MAYFLOWER PLATINUM

Details of Additions & Alterations

Flat No	502	Block no.	'A'
Flat Area	1500 sft	Type	Deluxe-/ Luxury
Buyer Name	Razia ahamed		
Phone No.	9989725581/9849323349	Email	raziaahamed@bel.co.in

Description	Direction	Owners & Developers :	Date :	Promoted by
WORKING DRAWING OF FLAT.NO.A-2	 N	Modi Properties Pvt Ltd.	Prepared By :	Modi Properties Pvt. Ltd Phone:+91-40-66335551
		Project Name & Phase :	Applied By :	
		MAYFLOWR PLATINIUM	Scaled By :	
		NTS

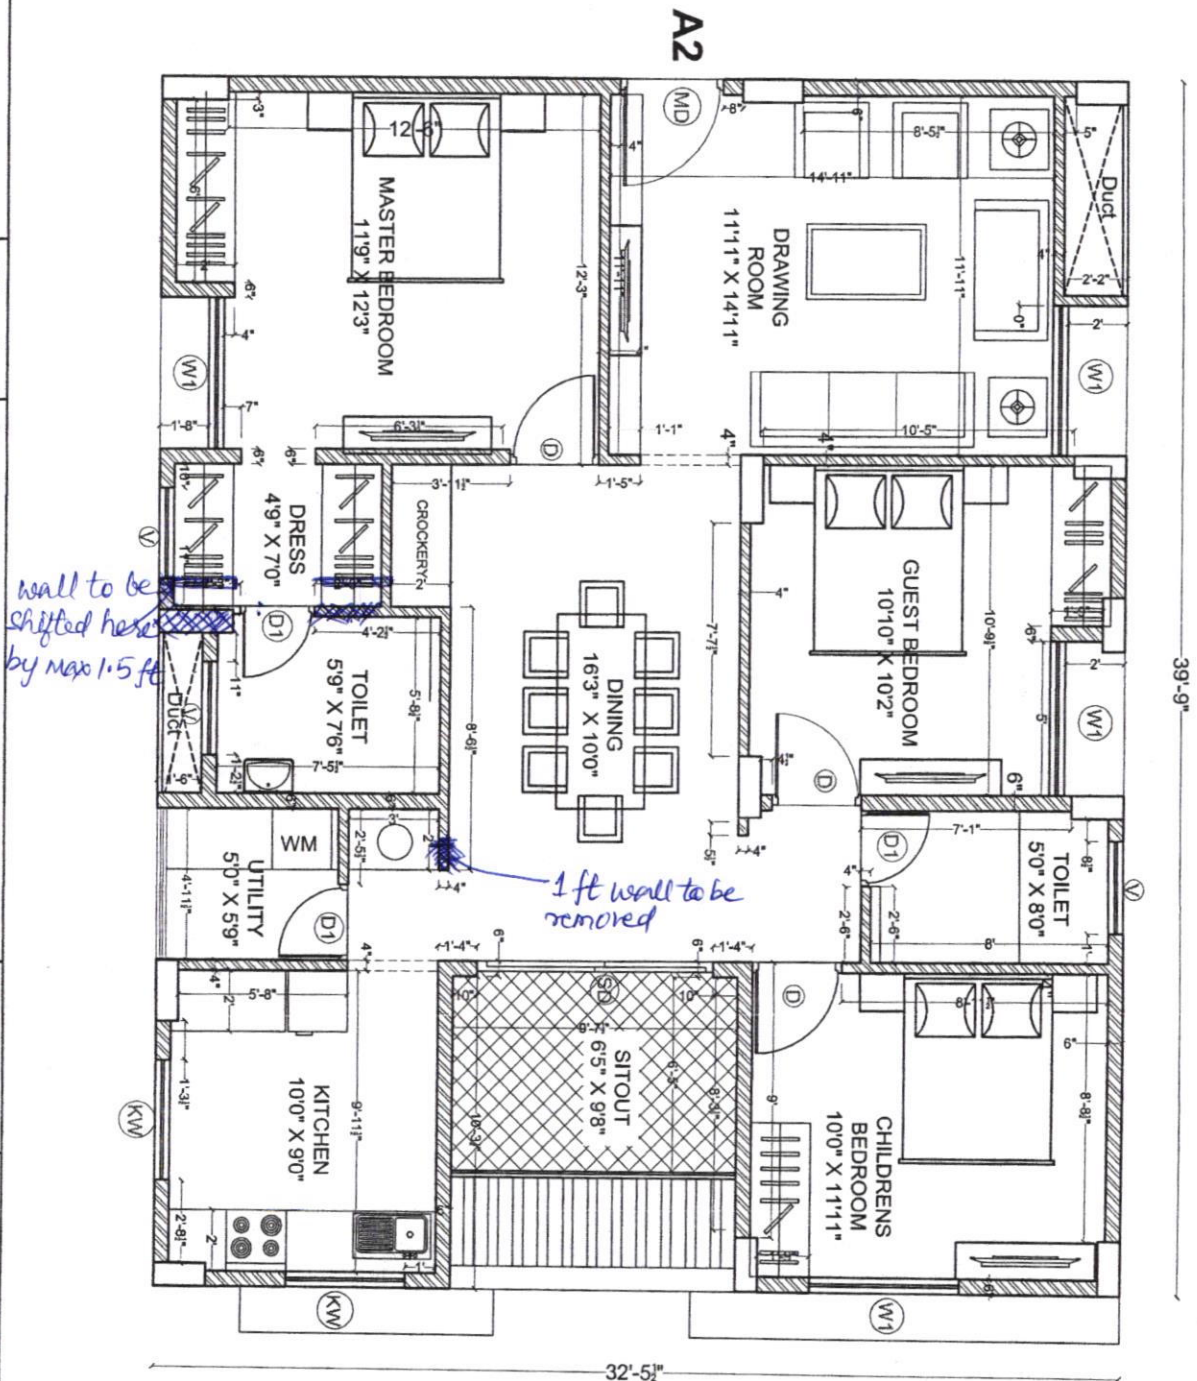
Shifting of Toilet wall in Master B'room towards door room by 1.5 feet.

In Common Toilet instead of WC, Indian Commode to be provided. Step height of Indian commode edges to be grounded. Wall mixture to be shifted by 1/2 feet towards the glass partition in both the toilets. T-type Taps for both the Health faucets to be provided in 2 Bathrooms.

Kitchen sink will be provided by us. Modular kitchen L-Shape platform to be provided from NE corner to South West (SE) corner.

Other Changes: Dining hall wash Basin partition wall should be reduced by 1.0 feet.

In Sit-out French window with Four track window with mesh to be provided.

ELECTRICAL PLAN OF FLAT-A2

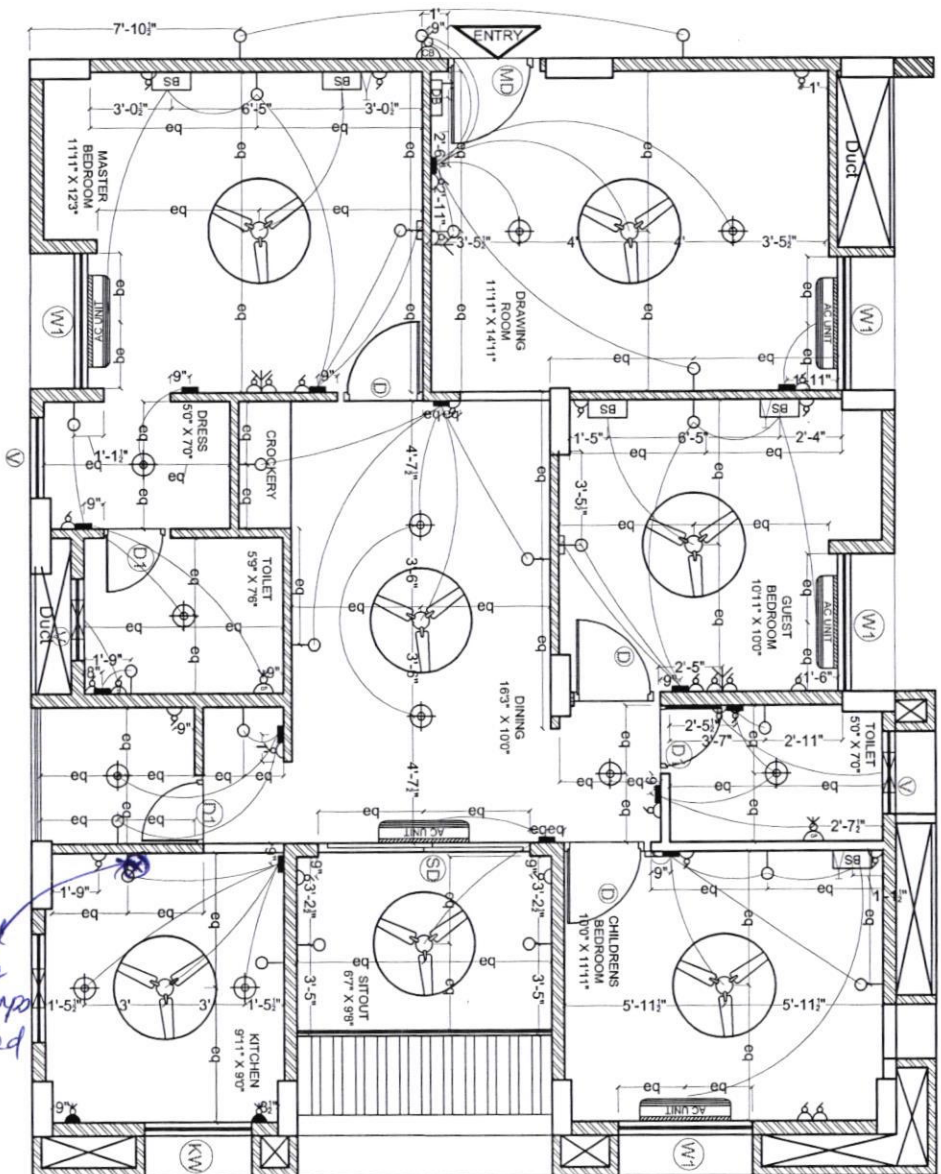
Beside fridge additional point for Microoven (16amps) to be provided.

Additional 16 amp point to be provided
